UNITED STATES PATENT AND TRADEMARK OFFICE

APPLICATION NO.	FILING DATE	FIRST NAMED INVENTOR	ATTORNEY DOCKET NO.	CONFIRMATION NO.
10/536,545	11/07/2005	Larry Salvadori	20518/51 (S-8500)	9818
7590 Tyco Healthcare Gap LP IP Legal Dept. 15 Hampshire st. Mansfield, MA 02048		09/28/2007	EXAMINER CAMPBELL, VICTORIA P	
			ART UNIT 3709	PAPER NUMBER
			MAIL DATE 09/28/2007	DELIVERY MODE PAPER

Office Action Summary

DETAILED ACTION

Fig. 1

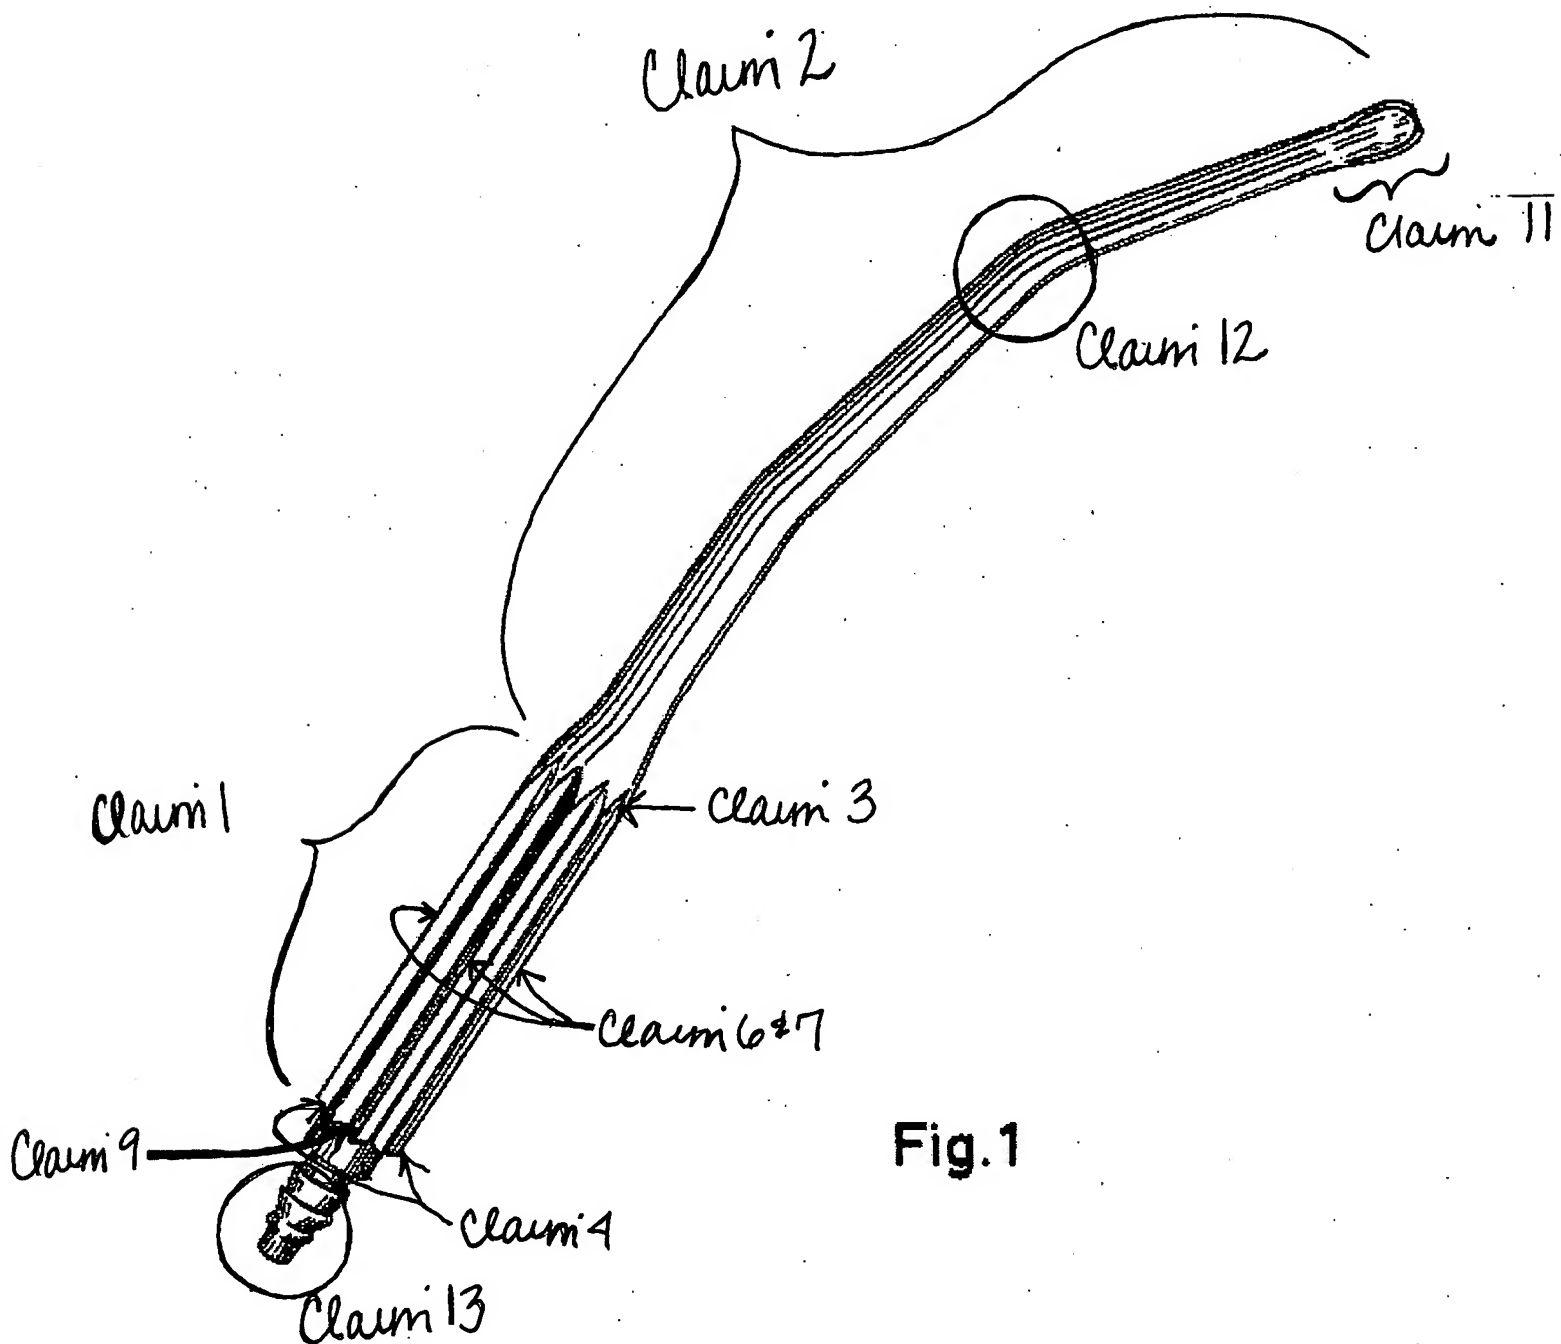
9. Claims 1-4, 6, 7, 9, and 11-14 are rejected under 35 U.S.C. 102(b) as being anticipated by US Design Patent No. 264,246 to Ekbladh et al. Regarding the abovementioned claims, Ekbladh et al teach the following (see attached drawing distinctly pointing out claimed features on Figure 1 of D264,246):

Claim 1: A surgical instrument comprising: a handle defining a longitudinal axis, the handle having an outer surface including a plurality of longitudinal fins that define a plurality of longitudinal grooves therebetween.

Claim 2: The surgical instrument of claim 1, further comprising an elongated tubular portion having an opening configured for suction.

Claim 3: A surgical instrument as recited in claim 1, wherein at least one of the fins project radially from the outer surface.

Claim 4: A surgical instrument as recited in claim 1, wherein a pair of the fins project radially from the outer surface and are diametrically opposed.

Claim 6: A surgical instrument as recited in claim 1, wherein two separate pairs of the fins project radially from the outer surface and are diametrically disposed.

Claim 7: A surgical instrument as recited in claim 6, wherein the two separate pairs are offset 90° relative to the longitudinal axis.

Claim 9: A surgical instrument as recited in claim 1, wherein the grooves include guide channels that direct fluid to a proximal end of the handle.

Claim 11: A surgical instrument as recited in claim 2, wherein the tubular portion includes a passageway that extends to the opening having a nozzle.

Claim 12: A surgical instrument as recited in claim 2, wherein the tubular portion has a curvature adjacent a distal portion thereof.

Claim 13: A surgical instrument as recited in claim 2, wherein a proximal end of the handle has an attachment configured to communicate with a suction source.

Claim 14: A surgical instrument as recited in claim 1, wherein the surgical instrument has a center of mass located distal to the handle.

Regarding claim 14, the surgical tool depicted has a handle shorter than its elongated extension. Both portions have similar diameters, therefore the mass of the elongated extension will pull the center of mass distal of the handle.
